**August 21, 2014
BOARD OF COUNTY COMMISSIONERS
ORANGE COUNTY, FLORIDA**

**ADDENDUM NO. 8
IFB NO. Y14-748 PH
ORANGE COUNTY EASTERN WATER RECLAMATION FACILITY
PHASE V AND CENTRIFUGE DEWATERING IMPROVEMENTS**

ORANGE COUNTY UTILITIES DEPARTMENT EASTERN WATER RECLAMATION FACILITY PHASE V IMPROVEMENTS CIVIL DETAILS	
PROJECT NO:	60222491
CAD DWG FILE:	C-511
DESIGNED BY:	WDM
DRAWN BY:	QRR/DLP
DEPT CHECK:	CPE
PROJ CHECK:	MDC
DATE:	OCTOBER 2013
SCALE:	AS NOTED
C-511	
68 OF 527

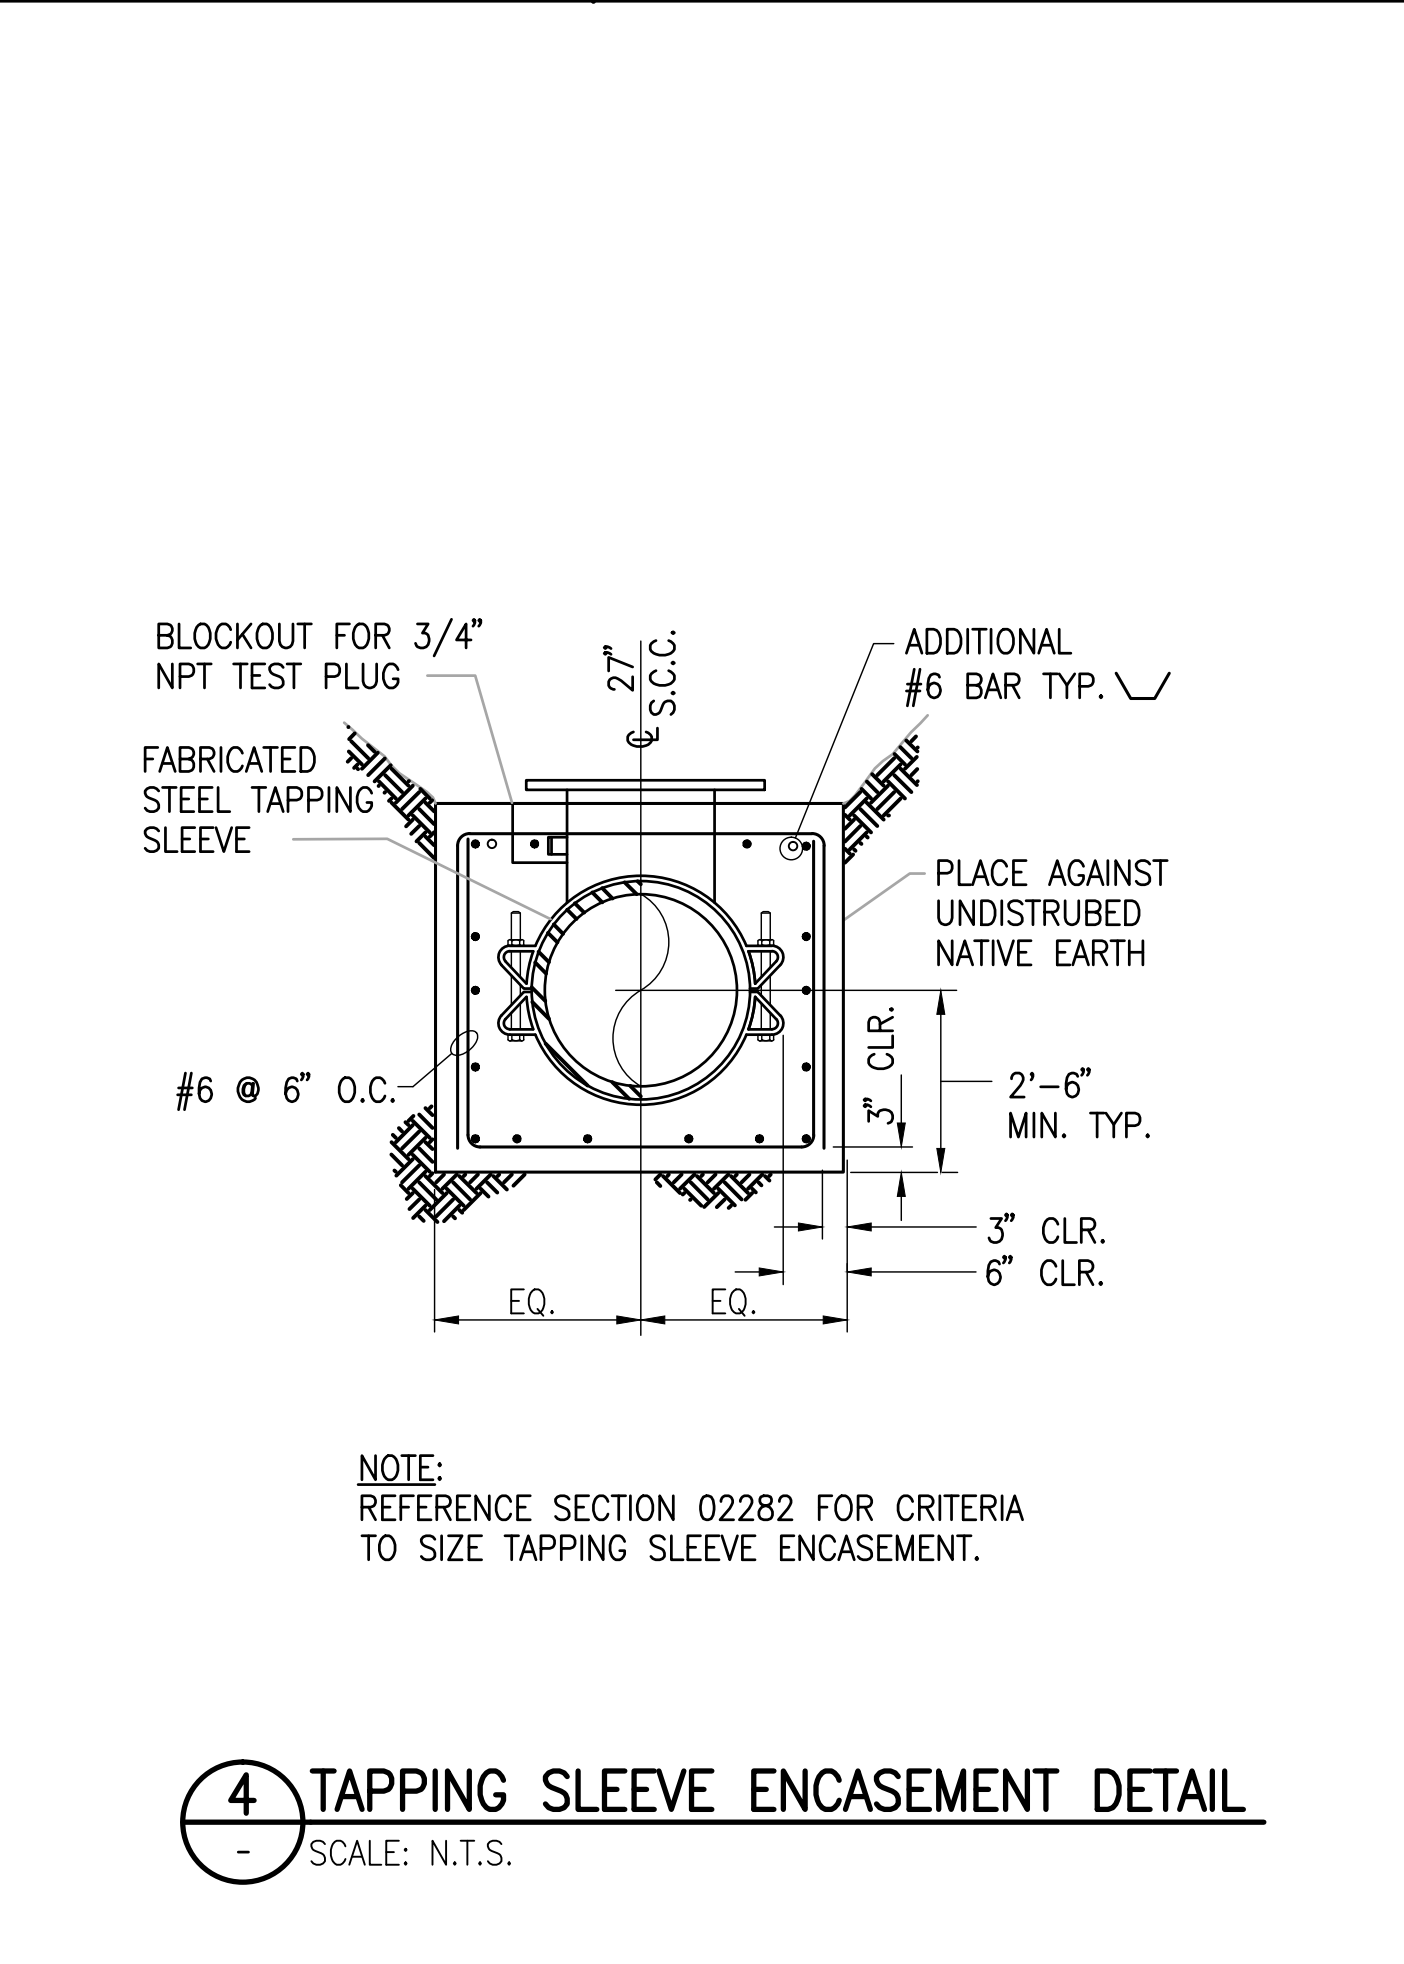
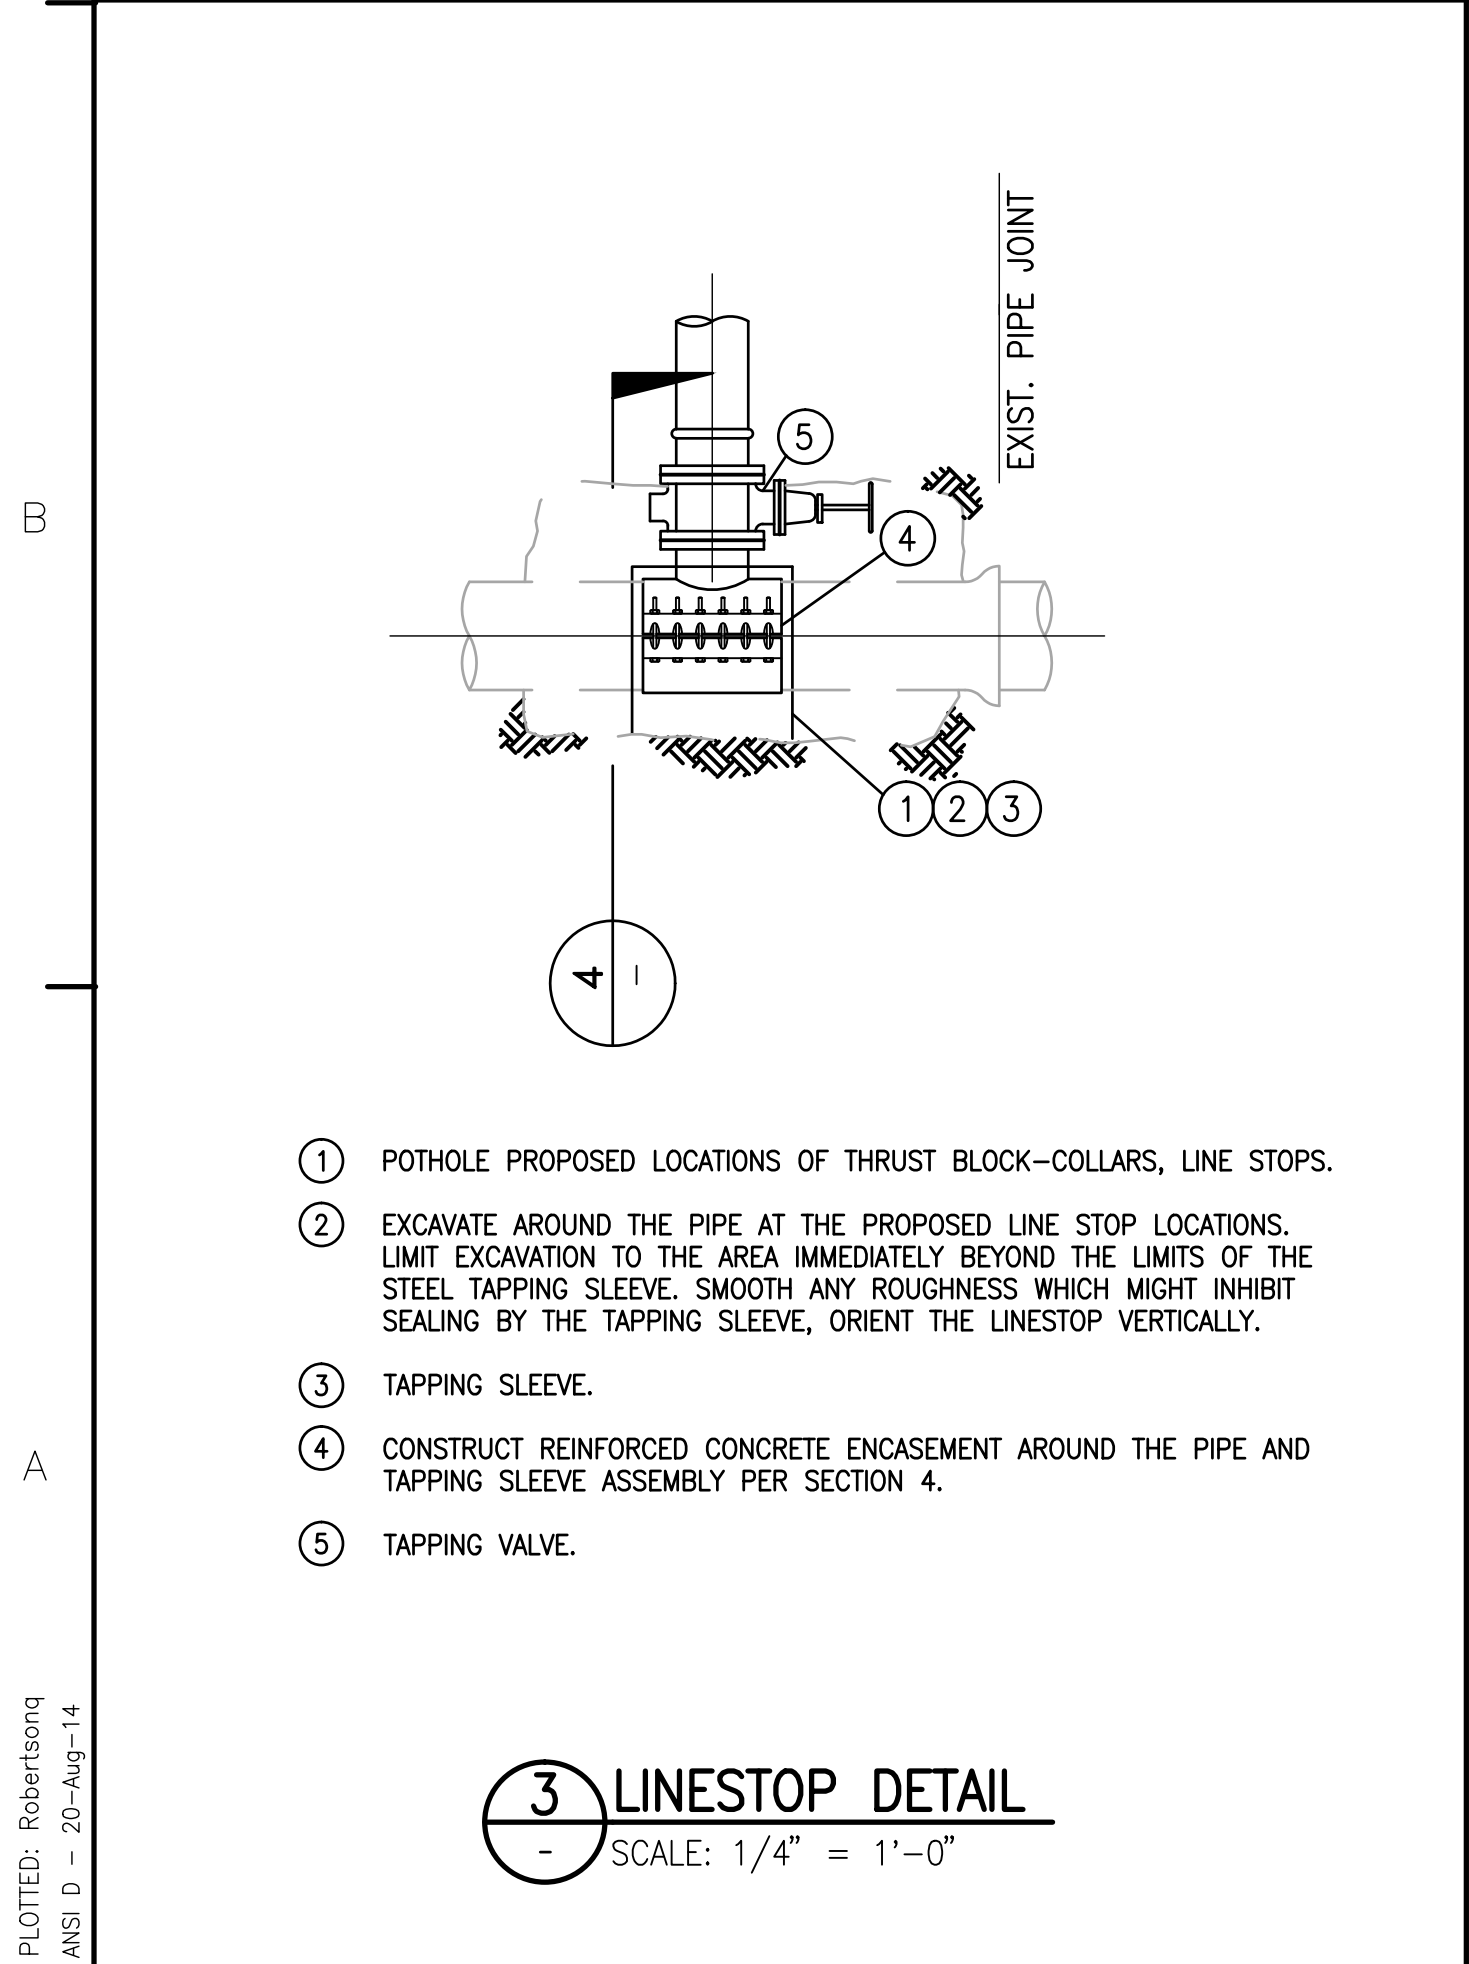
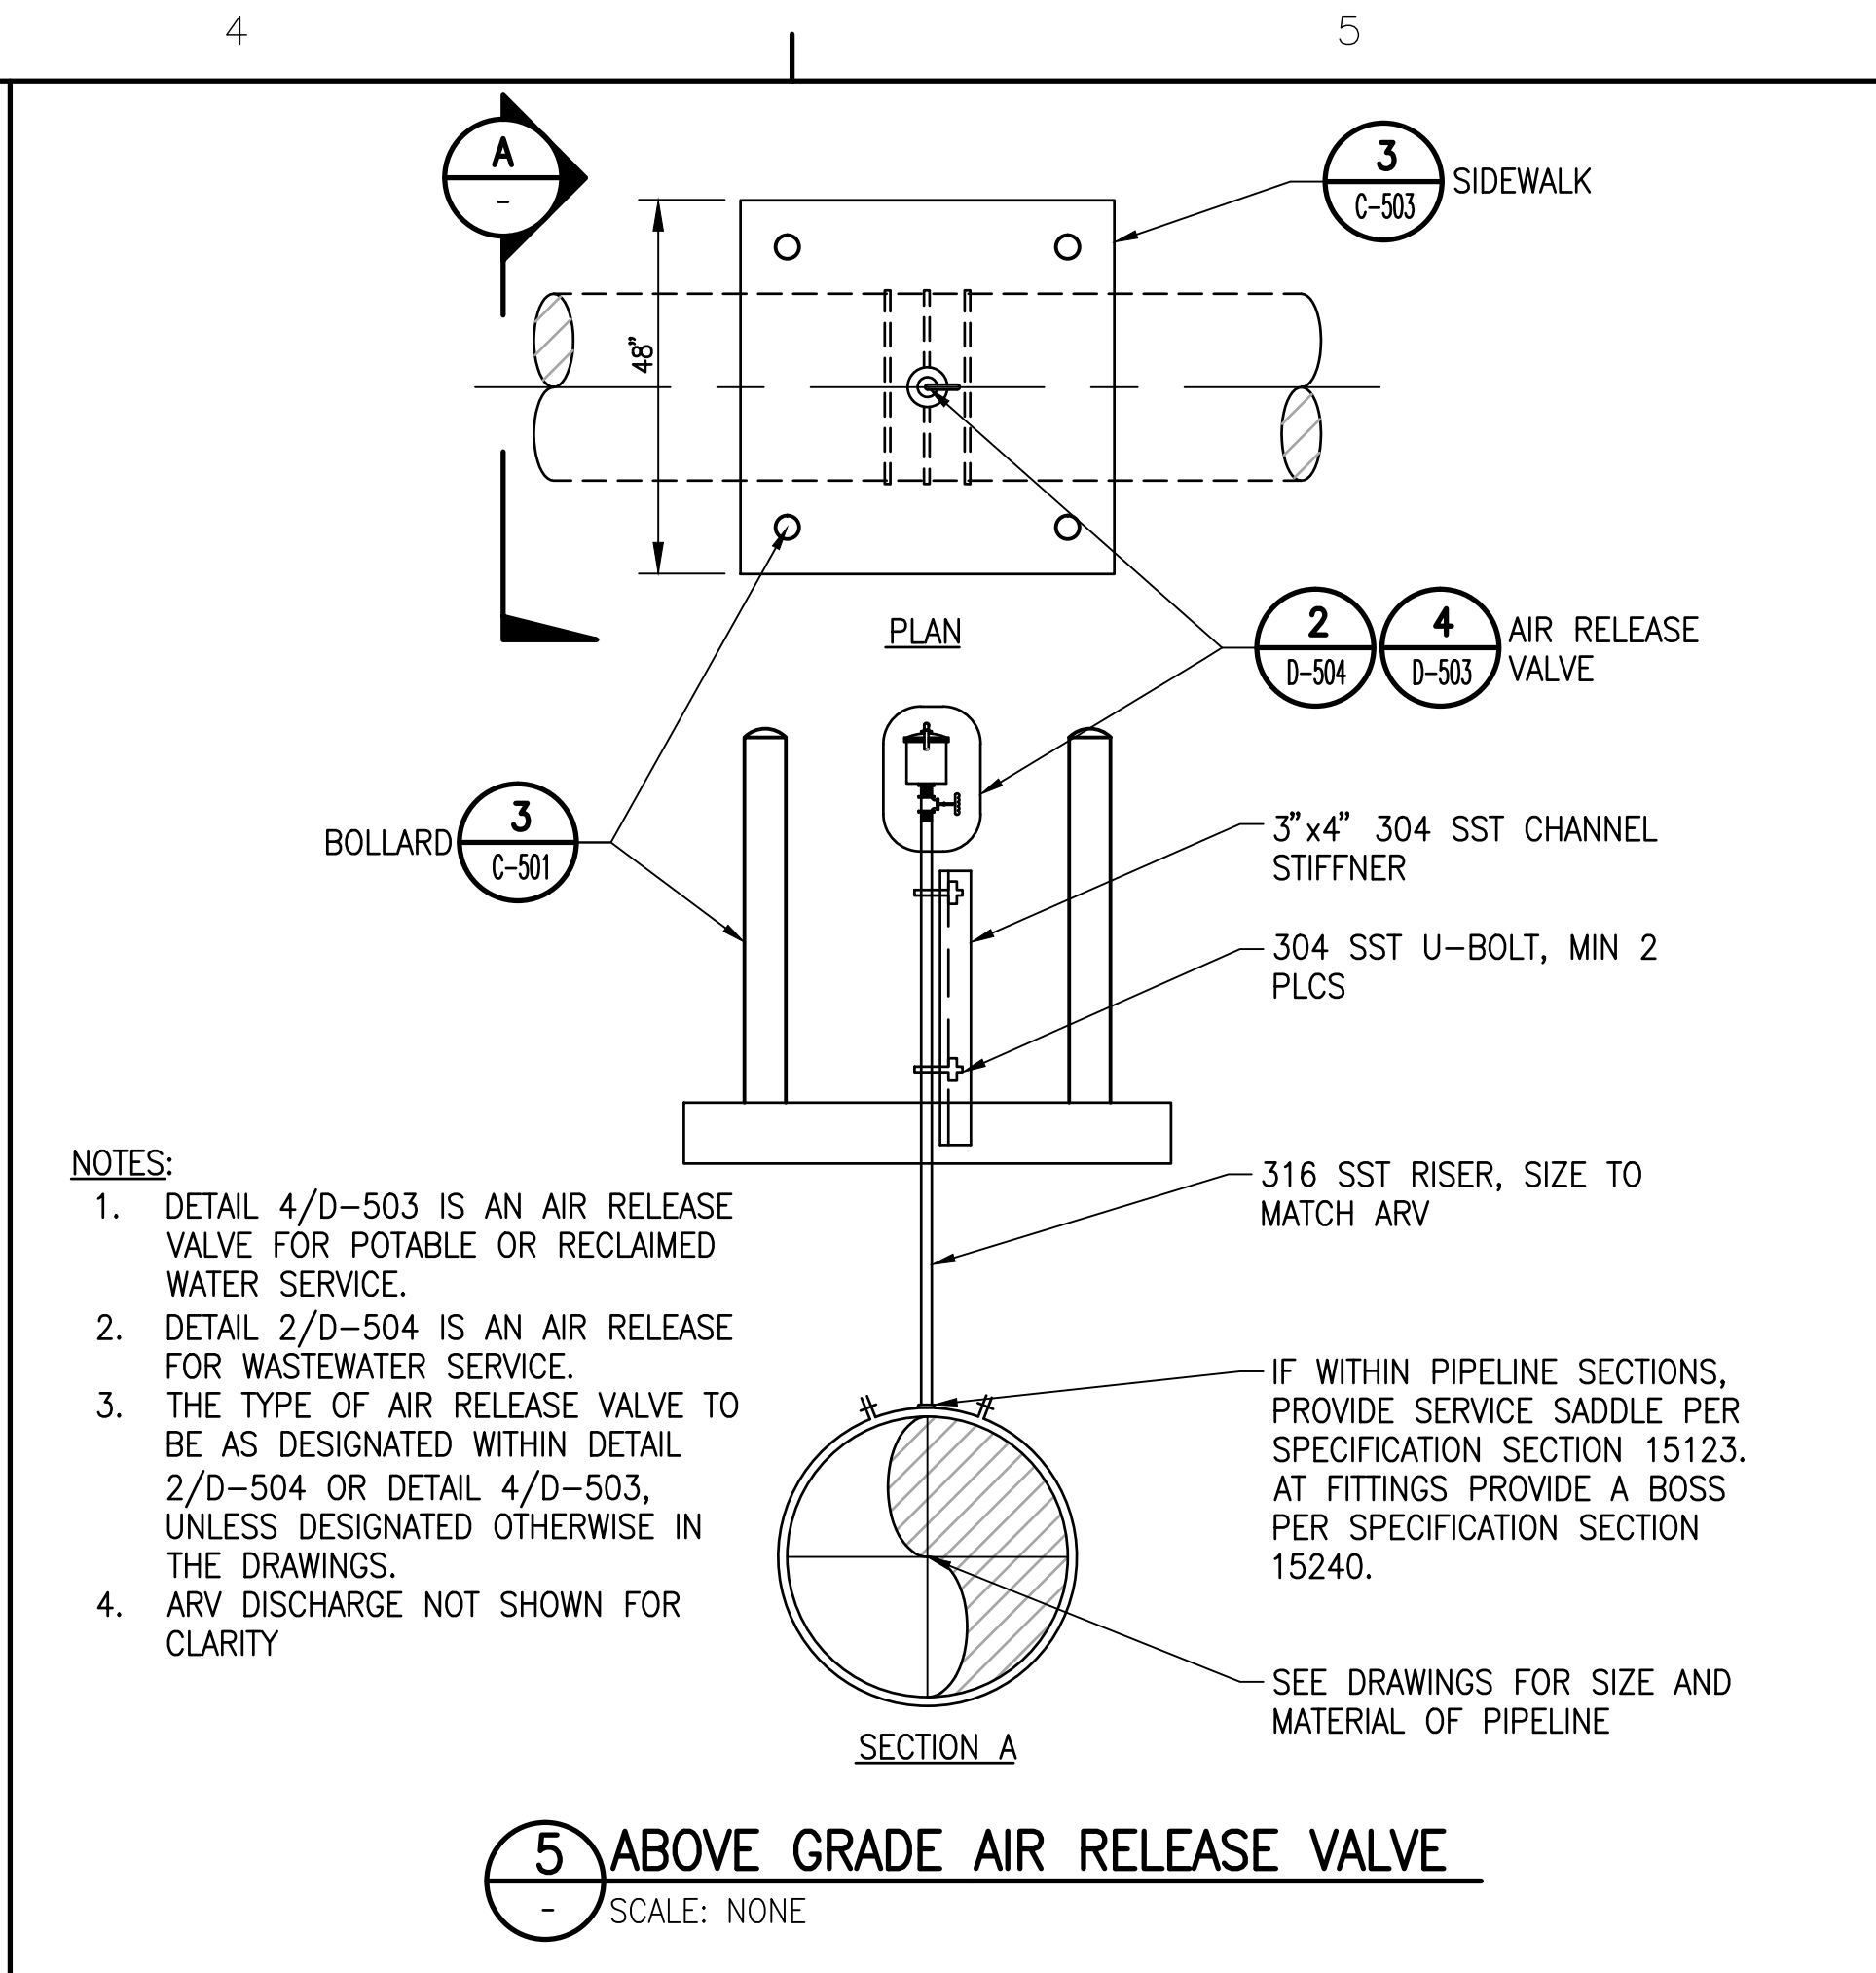
14. Bid Package A: Detail 1 on sheet C-511 references Section 02665 for spacing and locations of the Sch. 40 PVC vents. However, I was unable to find this information in Section 02665. Please provide information regarding the location, quantity, and spacing of the vents.

The Slope Ventilation Detail on Drawing C-511/Detail 1 is revised to note in the perspective view of the detail to include an interval for the vertical vents to be placed at 250' on center around the perimeter of the Reject Storage Pond. Please reference Note 3 on the revised and Specification Section 02665 regarding the responsibilities of the Liner System Engineer to prepare the submittal providing the specific number and location of vents. Note 3 is revised as follows; ~~REFERENCE SECTION 02665 FOR THE CRITERIA TO DEFINE SPACING AND LOCATION OF VENTS~~ SPACING TO BE SPECIFIED BY LINER SYSTEM ENGINEER PER SECTION 02665 (Attachment)
